CITY OF SAN ANTONIO
DEVELOPMENT SERVICES DEPARTMENT

Re: **Persyn Tract – Minor Amendment**

MDP# 010C-06

DESIGNER:
MASTER DEVELOPMENT PLAN
for
PERSYN TRACT #010C-06
MINOR AMENDMENT

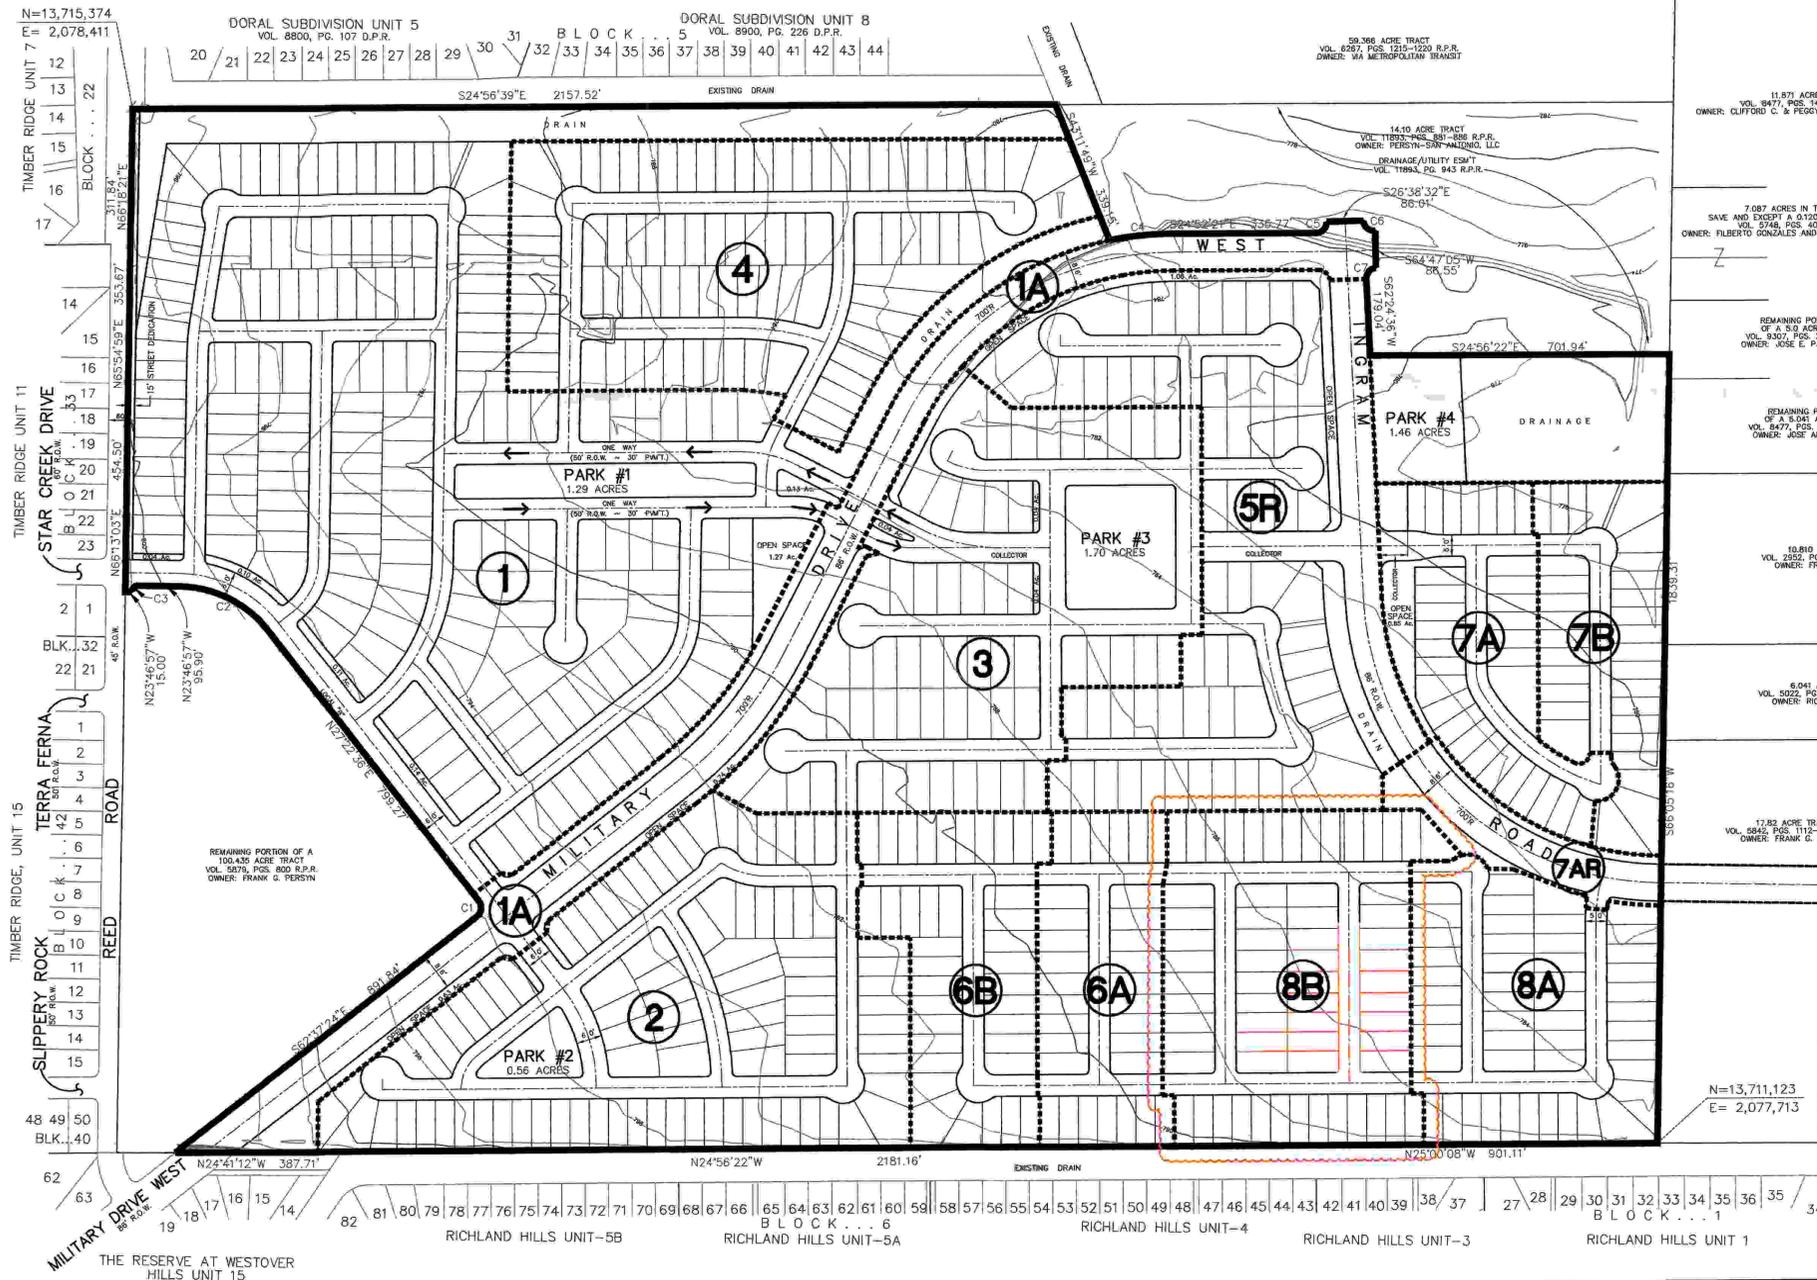
The Development Review Committee has evaluated the **Persyn Tract – Minor Amendment** Master Development Plan (**MDP # 010C-06**). Enclosed is an accepted and signed copy of the MDP for your files. However, please note the following conditions:

It will be expected that all of the property depicted in the Master Development Plan including but not limited to floodplains, drainage areas, and open space shall be platted. All platting shall comply with the Unified Development Code (UDC), the City's Master Plan, Major Thoroughfare Plan, and all applicable regulations for the City of San Antonio.

Please note that this action by the committee does not establish any commitment or support for the provision of drainage, utilities, services, or zoning of any type now or in the future by the City of San Antonio. In addition, it is suggested to work closely with the **Northside Independent School District**, so they can plan for the development accordingly.
